OHISTORIC PRESERVATION BOARD STAFF REPORT

Sundy Village – Block 61

Meeting	File No.	Application Type
November 6, 2024	2024-233	Level 1 Site Plan Modification and Certificate of Appropriateness

The item before the Board is consideration of a Level 1 Site Plan Modification and Certificate of Appropriateness (2024-233) request for exterior modifications to the existing historic structures within the **Block 61 portion of the Sundy Village project, Old School Square Historic District.**

HOOD SCREENING PLAN
SCALE: 1 1/2" = 1'-0"

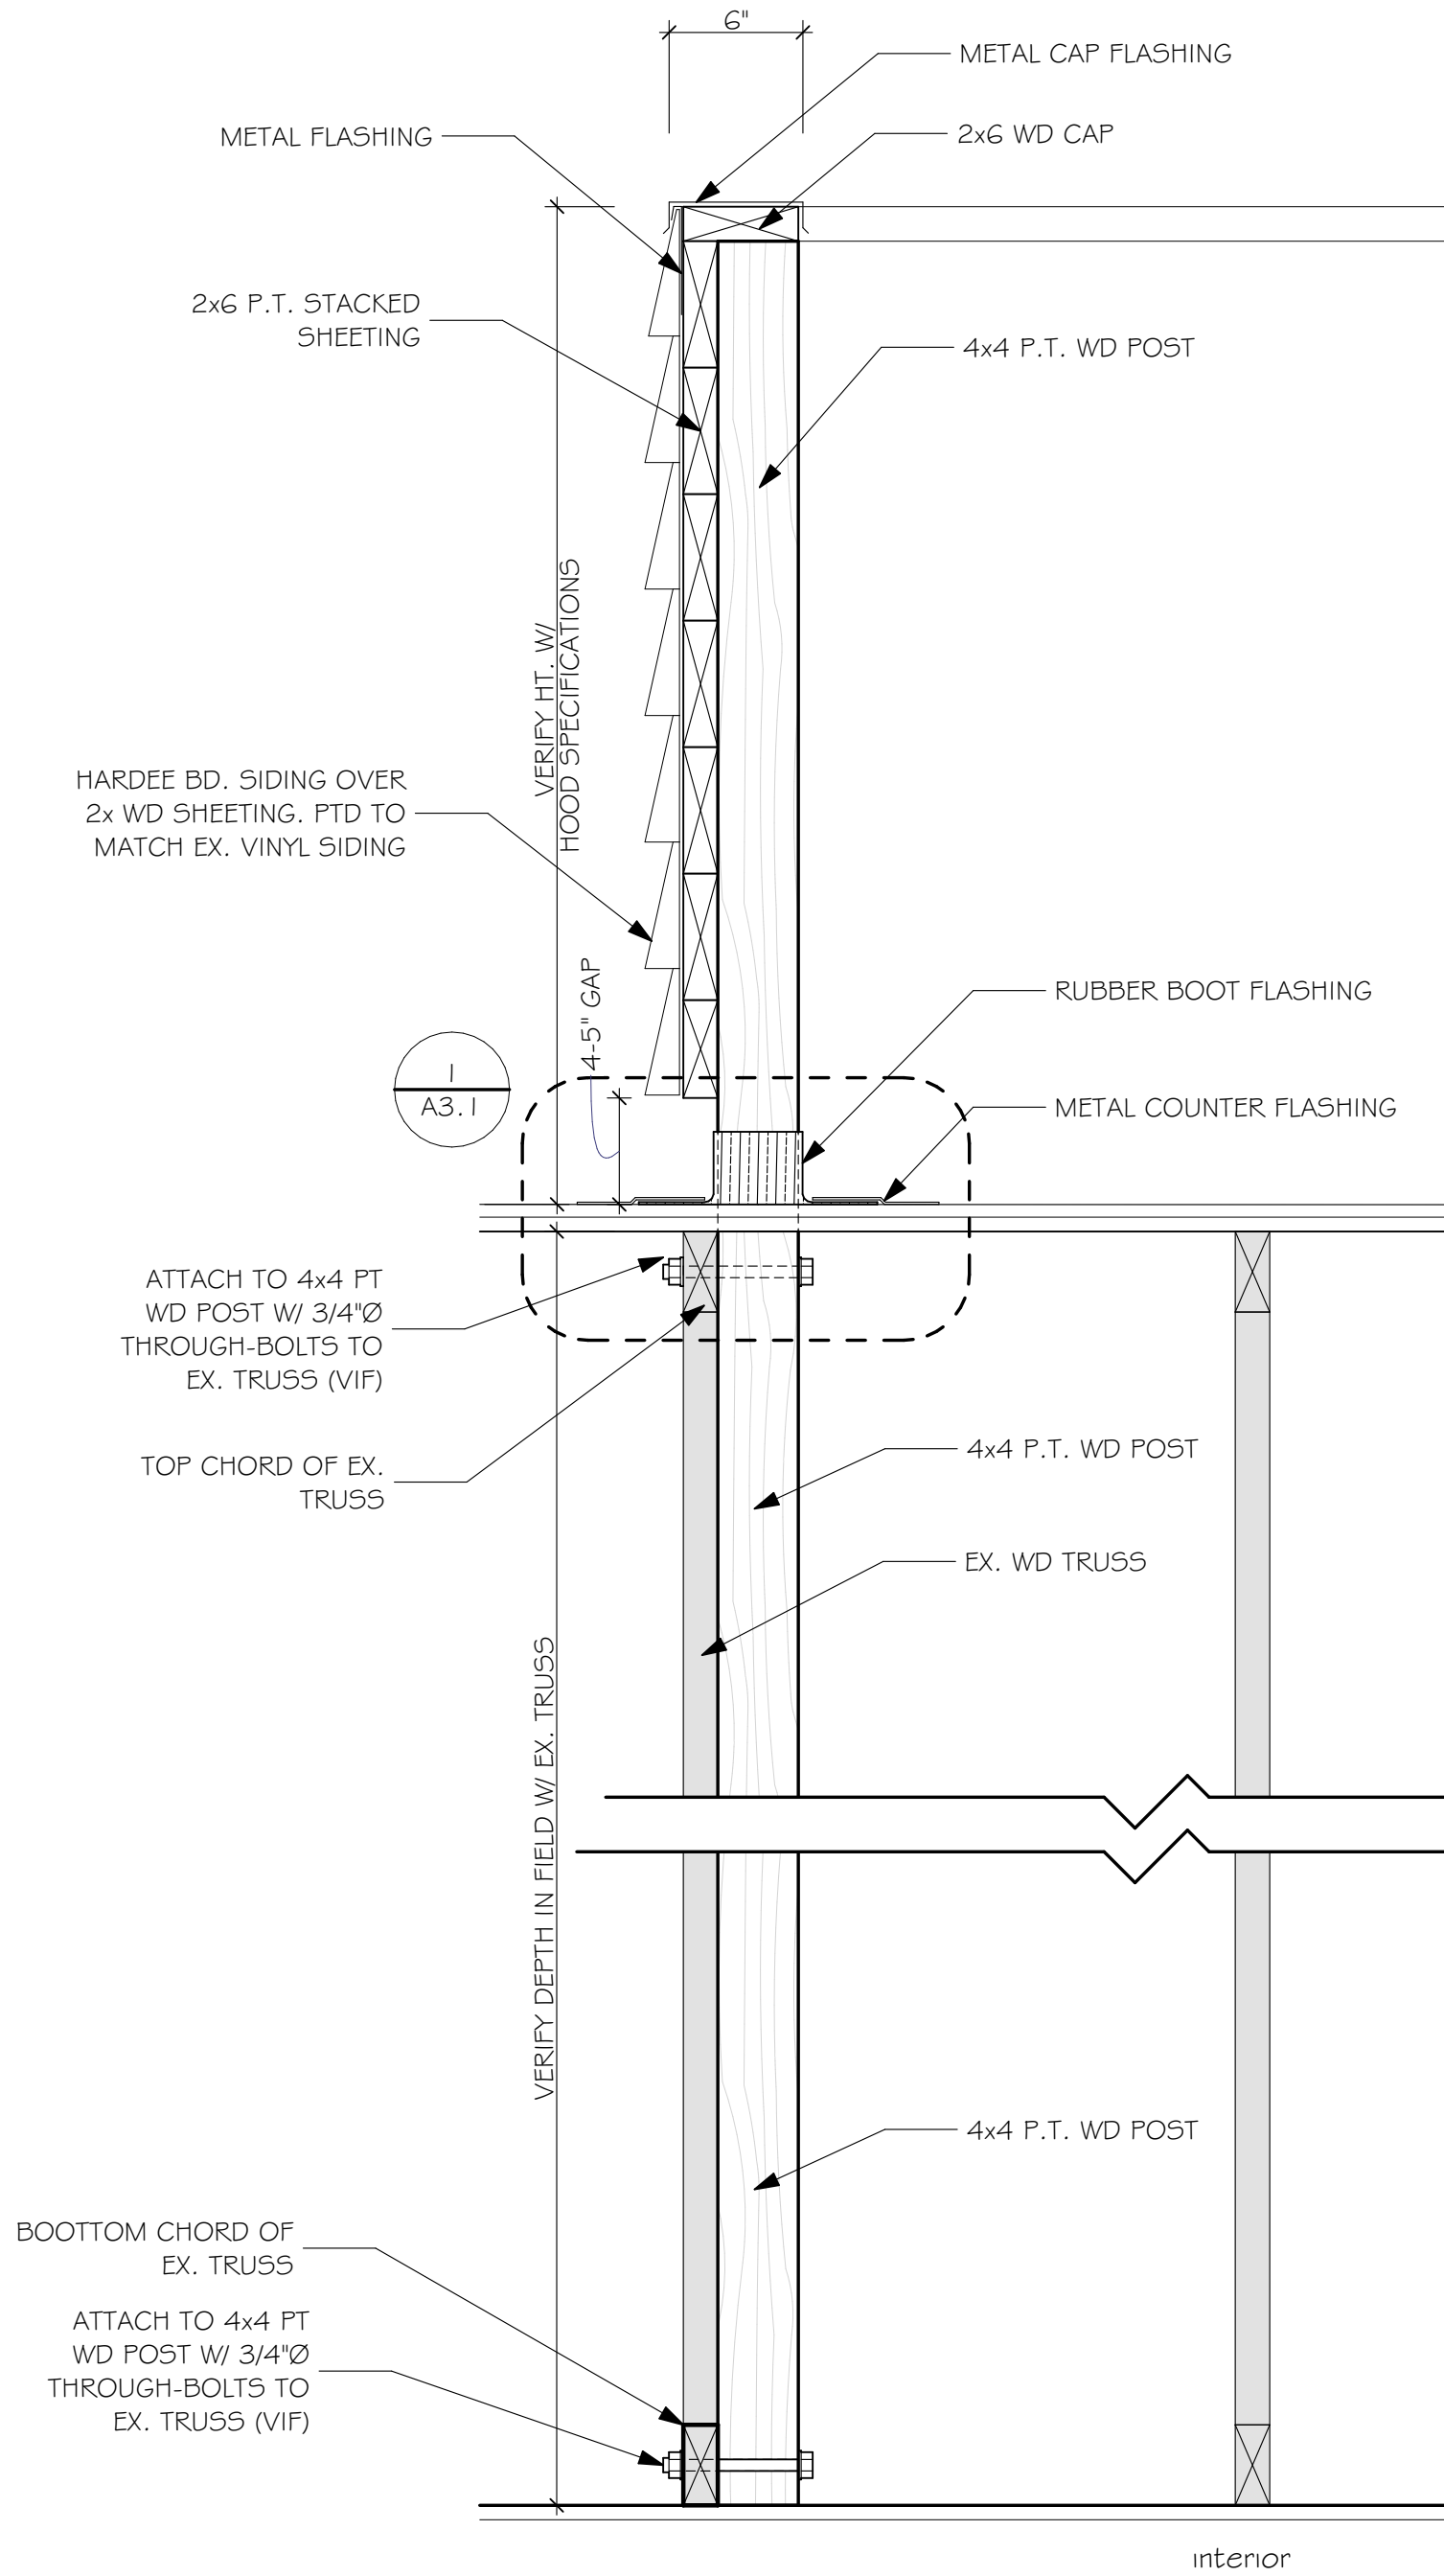
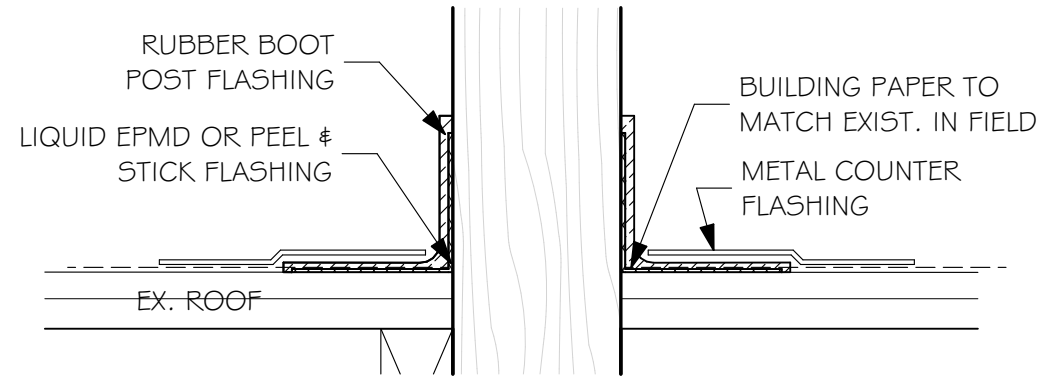
The subject request includes the exterior modifications of constructing hood vents with screens on the roofs of all historic structures that require them for restaurant purposes. It is noted that the request includes all five (5) historic structures on Block 61 of the Sundy Village site, however they will only be added if required to accommodate the prospective tenants for the buildings. The hood vents and ADA ramps were originally submitted through building permit, however are exterior alterations that require review and approval by the HPB.

BUILDING A ELEVATIONS

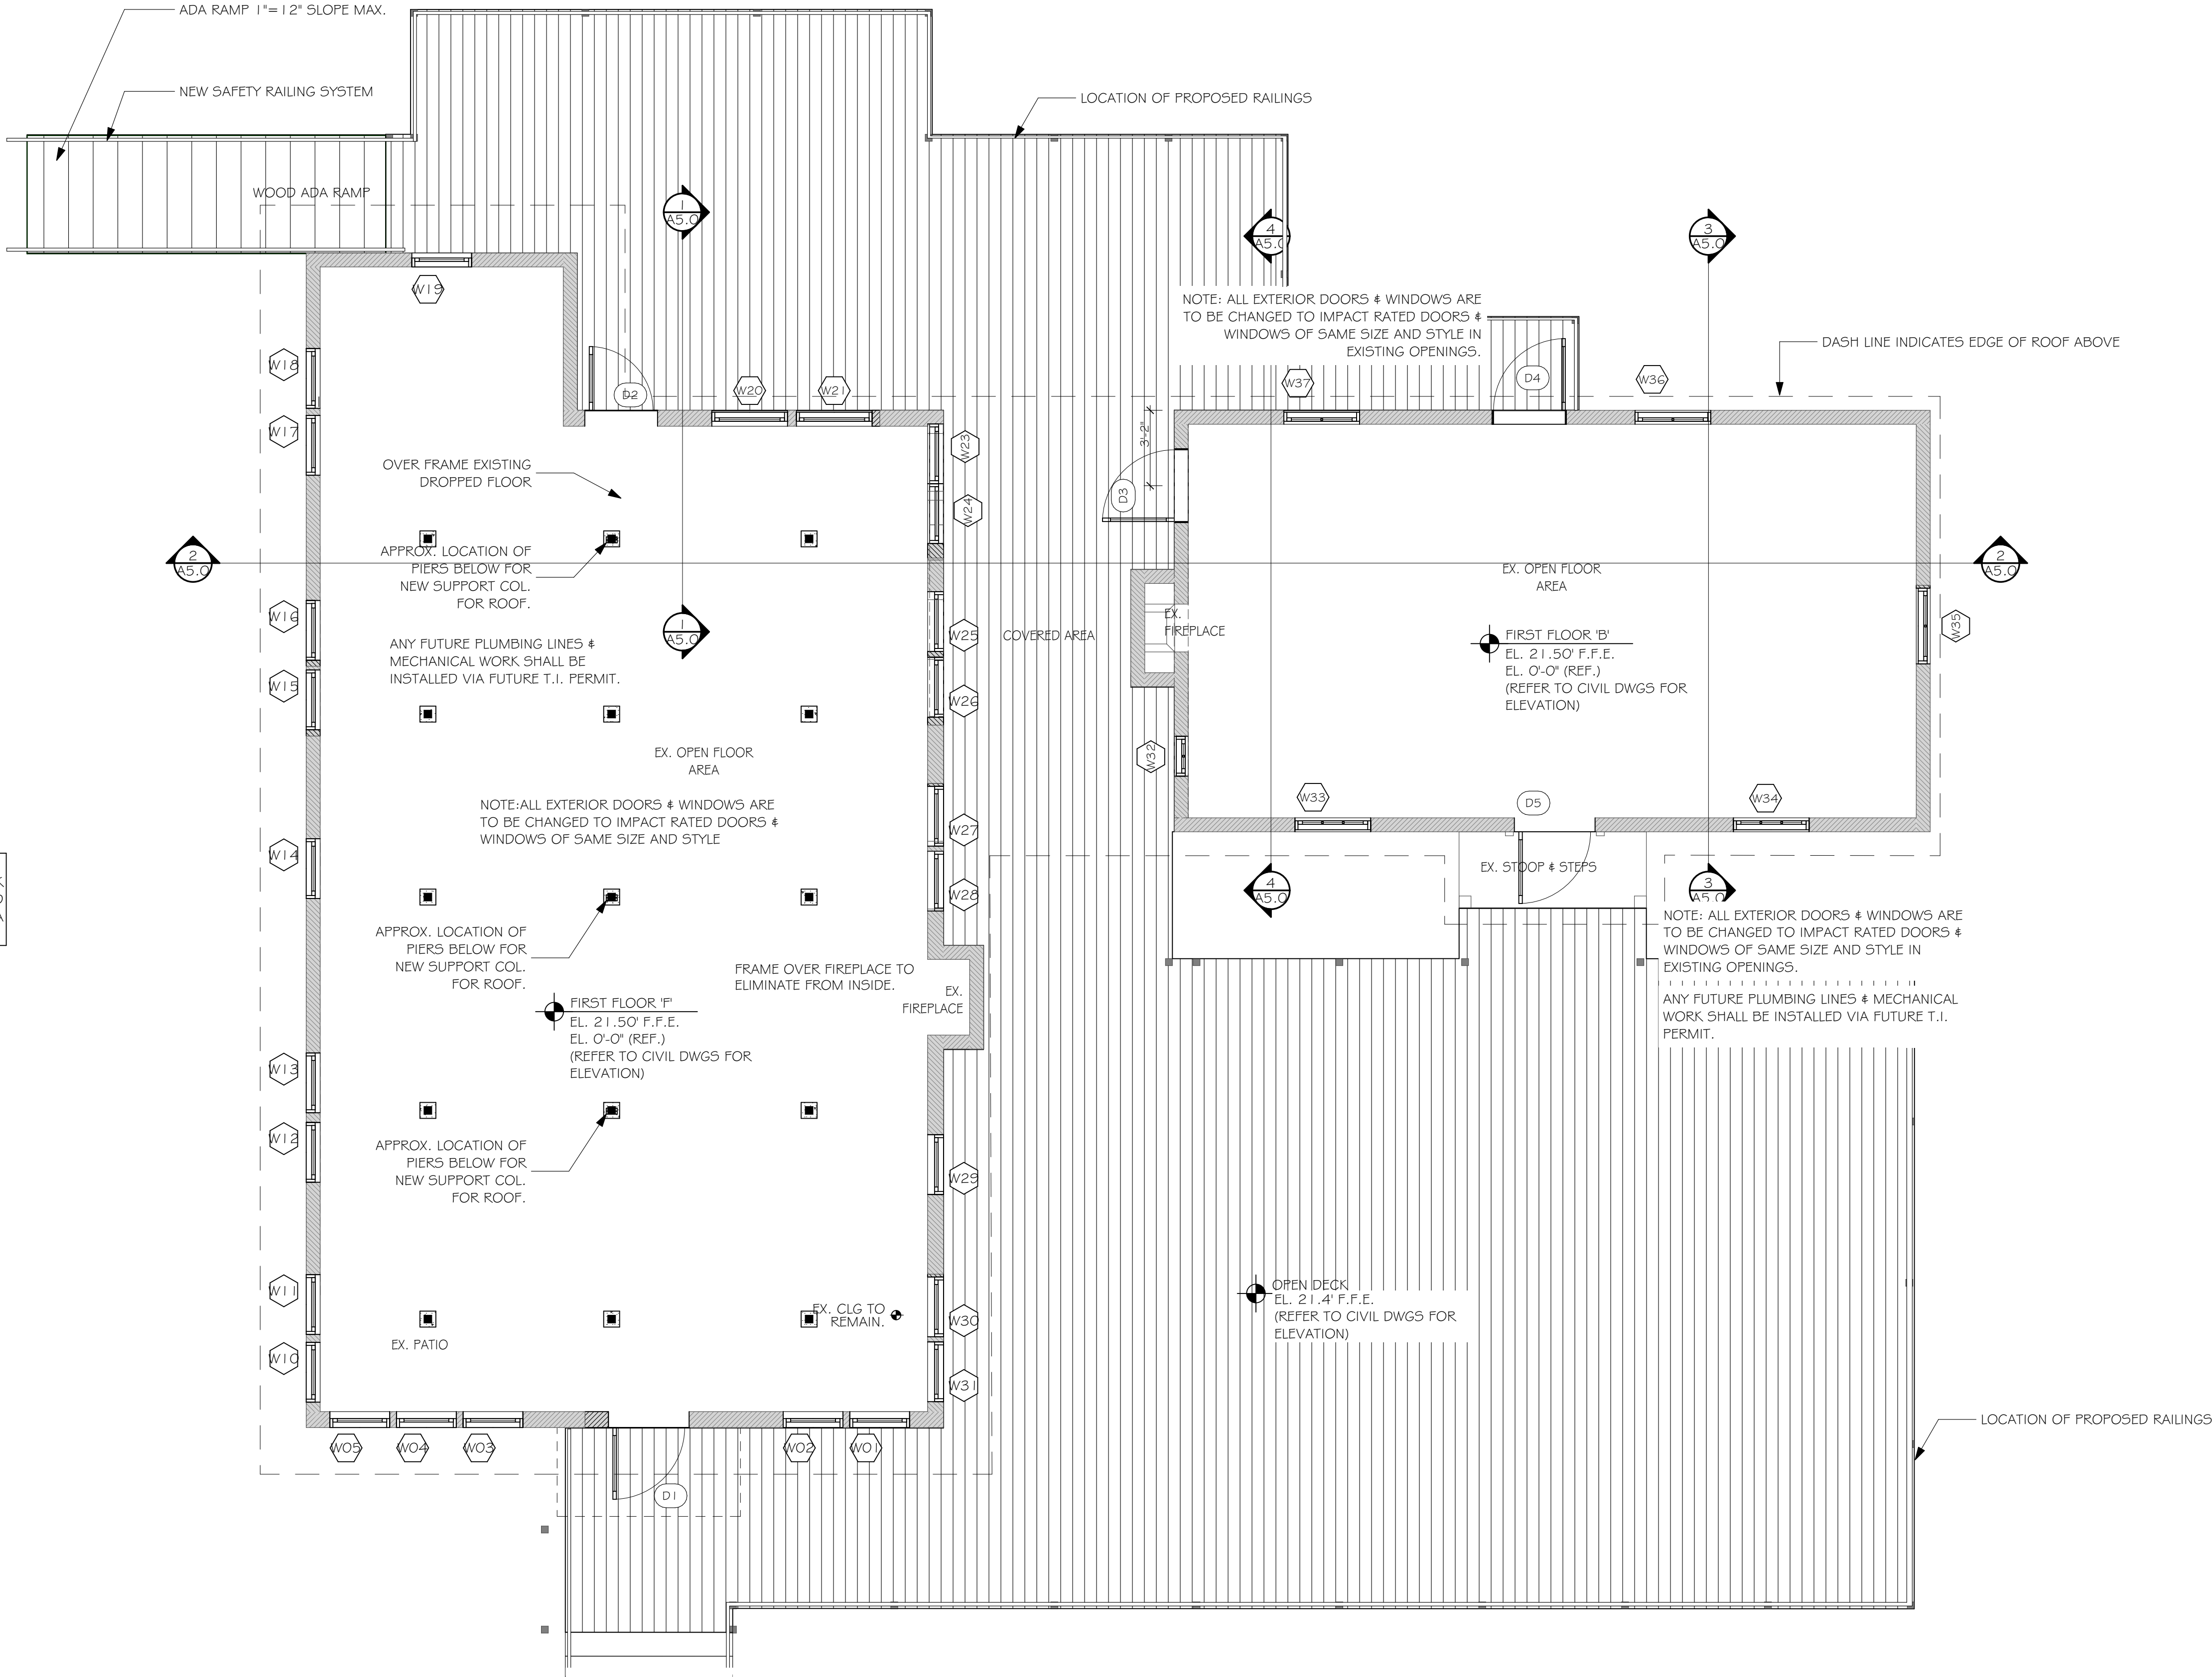
As for **Roof Shapes**, there are no proposed changes to the roof shapes for the subject structures, however it is noted that two hood vents will be placed on the roof to the rear (west) sides of the building, where they will be the least visible from the public right-of-way and so as to not interfere with the historic integrity of the front façade. Their designs are to appear like chimneys. With regard to Building A – The Rectory, staff had already been previously notified that the chimney was to be removed from the structure. However, as the certified elevations did not show this change, the elevations have now been revised to depict the structure as it currently exists with the chimney removed.
